SLO Valley Basin Groundwater Sustainability (GSP) Public Comments

Last Updated: 7/26/21

Re: NOAA's National Marine Fisheries Service comments on the draft Groundwater Sustainability Plan (Chapter 5) for the San Luis Obispo Valley Groundwater Basin

NOAA's National Marine Fisheries Service's Comments on the draft Groundwater Sustainability Plan (Chapter 5) for the San Luis Obispo Valley Groundwater Basin (March 2020)

Figure 1. San Luis Obispo Creek Intrinsic Potential Steelhead Spawning and Rearing Habitat.

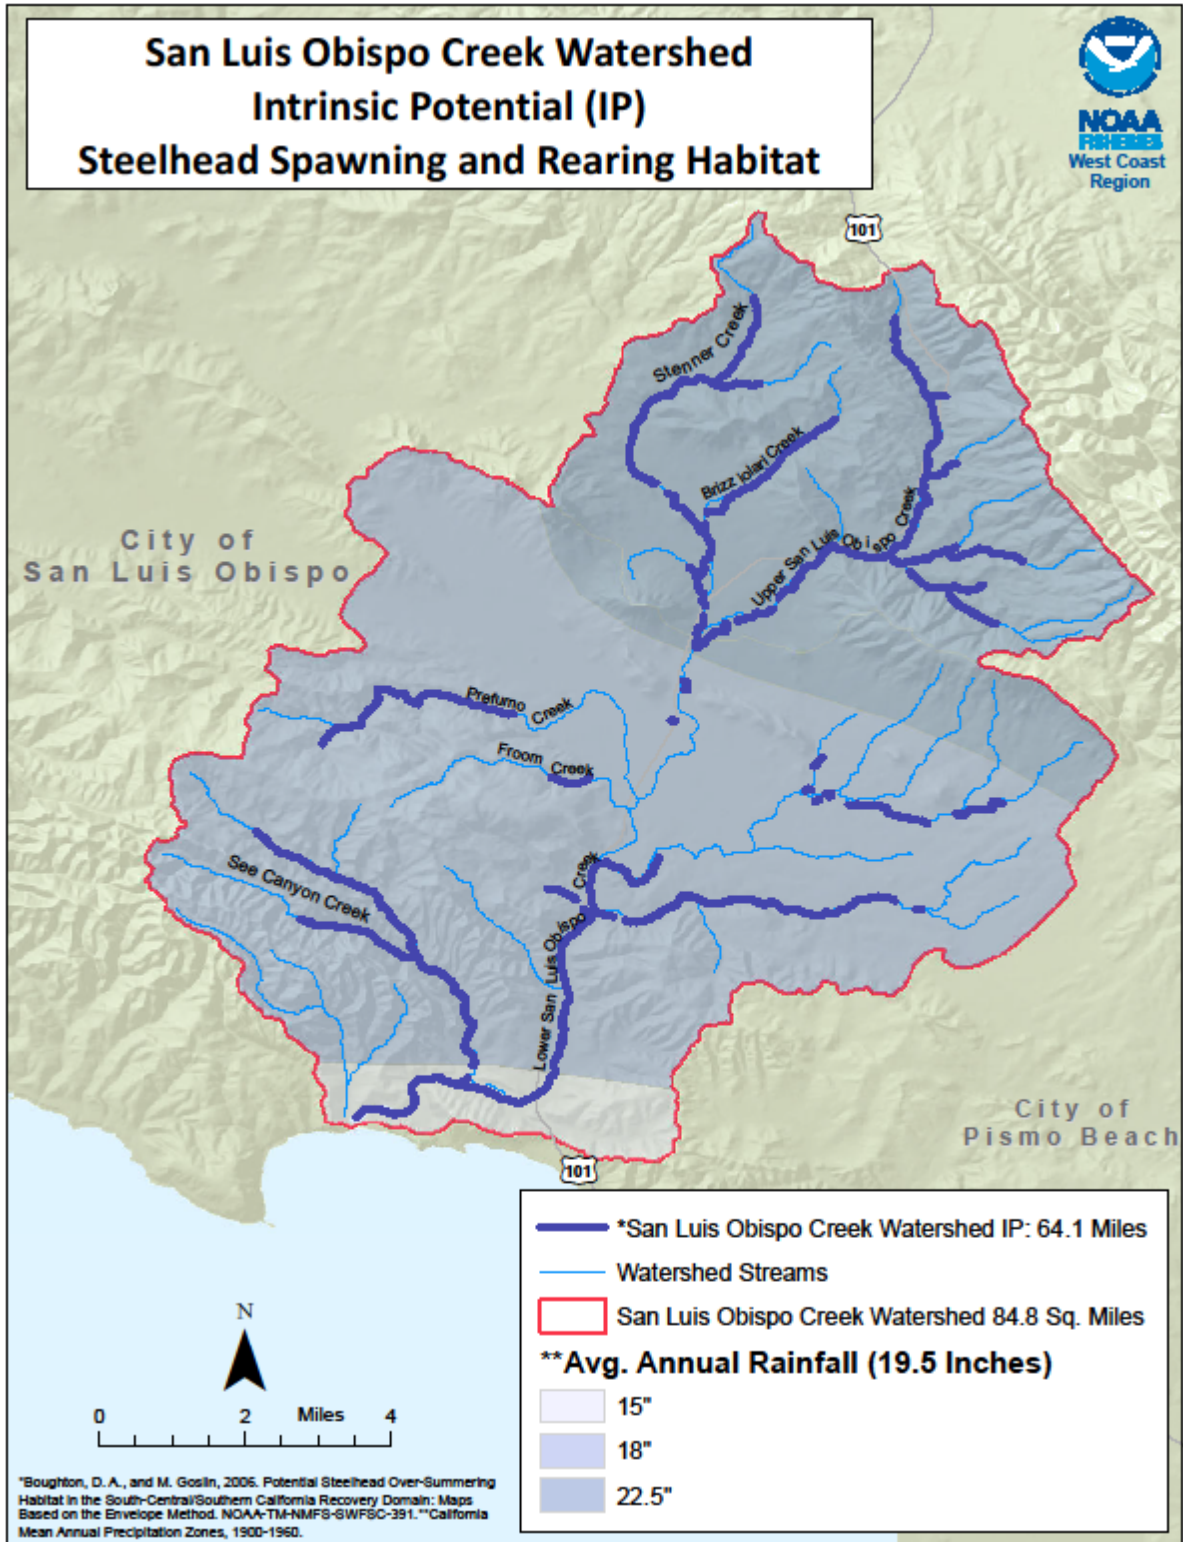
steelhead based on the amount of potential habitat (in an unimpaired state) in each watershed within the SC-CCS DPS. See Figure 1 and 2, “Intrinsic Potential Steelhead Spawning and Rearing Habitat maps for San Luis Obispo Creek and Pismo Creek included as part of Enclosure

Figure 4. Pismo Creek Critical Steelhead Habitat.

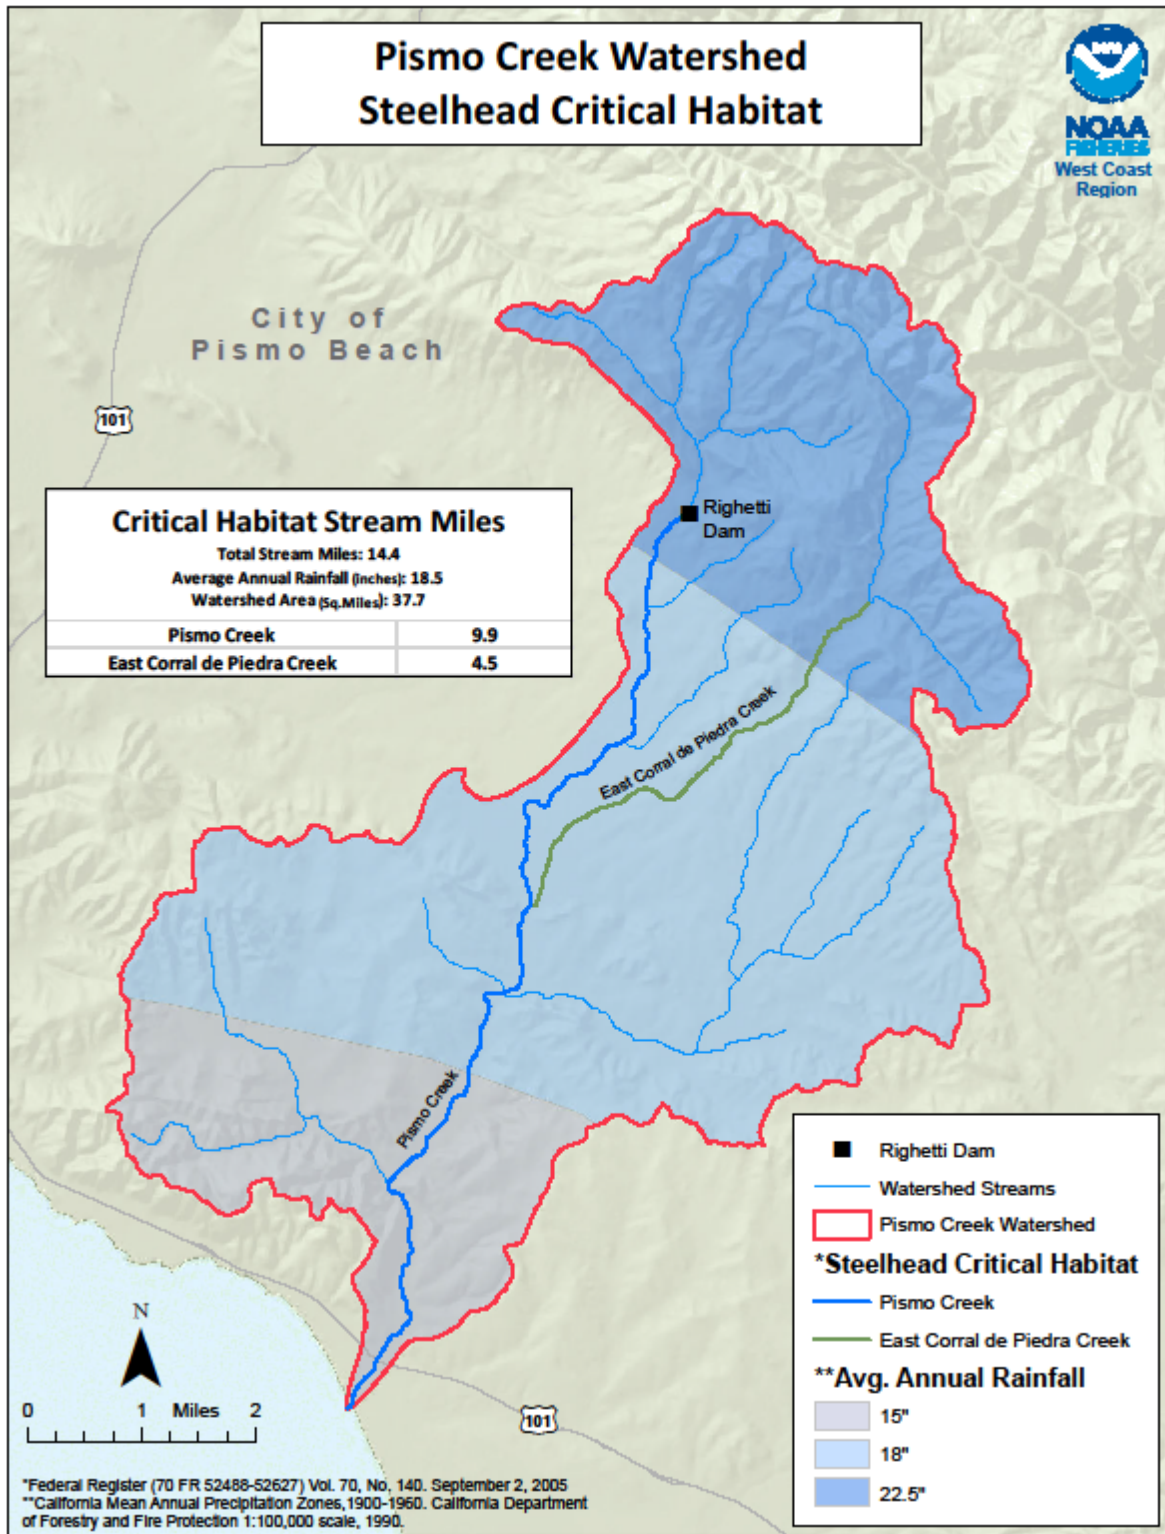
Critical habitat throughout the threatened SC-CCS DPS of steelhead has been adversely affected by loss and modification of primary constituent elements (substrate, water quality and quantity, water temperature, channel morphology and complexity, riparian vegetation, passage conditions, etc.) through activities such as groundwater extractions and related surface-water diversions (NMFS 2013). Thus many of the constituent elements of critical habitats have been significantly degraded (and in some cases lost) in ways detrimental to the biological needs of steelhead. These habitat modifications have hindered the ability of designated critical habitat to provide for the survival and ultimately recovery of the threatened SC-CCS DPS of steelhead. See Figures 3 and 4, “Critical Steelhead Habitat maps for San Luis Obispo Creek and Pismo Creek included as part of this Enclosure.
